Sub :- Proposal for Diversion of **2.206 Ha** of Forest Land for up-gradation of existing road from formation of BT road from ZP road 9/400 km to Naguguda of Tiryani RF of Asifabad Division of Kumuram Bheem District in favour of District Panchayat Raj Engineer, PIU, Kumuram Bheem Asifabad – **EDS raised by IRO, Hyderabad** – Revised replies submitted -Regarding.

Sub: - DPRE, PIU, KB Asifabad - PMGSY - Forest Clearance - **Diversion of 2.206 ha of forest land for formation of BT road from ZP road 9/400 km to Naguguda of Tiryani RF of Asifabad Division of Kumurambheem Asifabad District in favour of District Panchayathi Raj Engineer, PIU, (FAC), Kumurambheem Asifabad District (Proposal No. FP/TG/ROAD/124335/2021) - EDS raised by the IRO, Hyderabad, GOI - submission of EDS data - request to take necessary action - reg.**

FORMATION OF BT ROAD FROM ZP ROAD 9/400 Km TO NAGUGUDA OF TIRYANI MANDAL

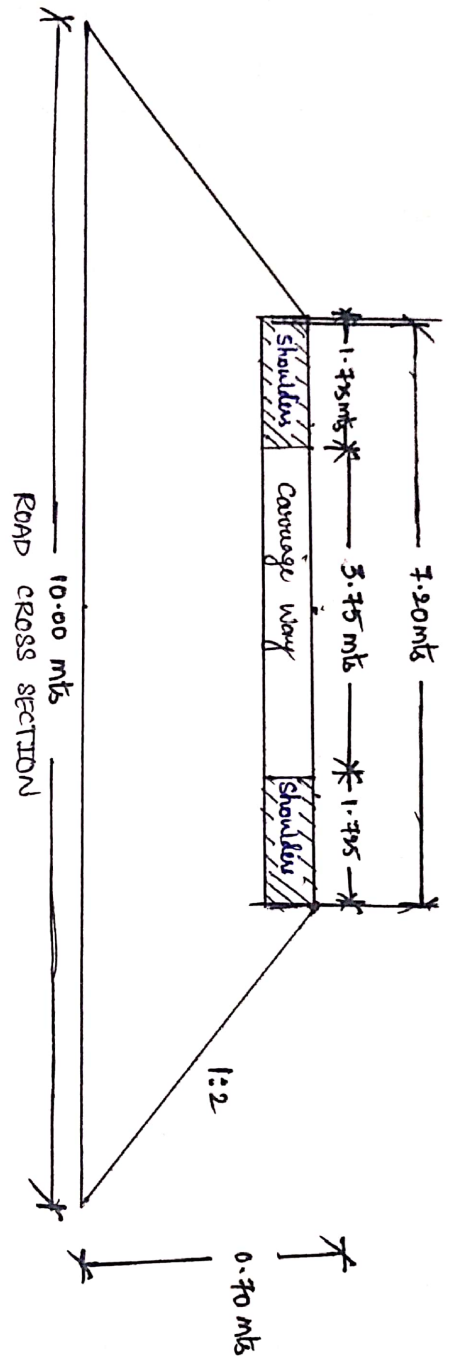
1. The extent of forest land proposed for diversion is shown as 3.6777 ha at S1.B and as 2.206 ha at S1.C of Part-I filled by the User agency in Parivesh portal. The area details need to be corrected in all relevant fields on Parivesh by the State Government and the User Agency.
2. Design, Cross-section and nature of the road proposed to be constructed needs to be submitted by the User Agency.
3. The user agency may explore the possibility of constructing all weather road instead of BT road as entire alignment is located in the Tiger habitat and the human population is very less in the area.

1. The Proposal is prepared with 10m width as per site condition for an extent of 3.6777 ha forest land as against 2.206 ha forest land with 6m width recommended by forest department. Hence it is requested to consider 10m width for the proposal for 3.6777 ha of forest land extent.
2. Design and Cross Section enclosed here with. The Nature of Road Proposed is BT Road.
3. All Possibilities are explored while preparation of proposals and as per the PMGSY guidelines it is need to construct BT Road, hence please consider for BT Road.
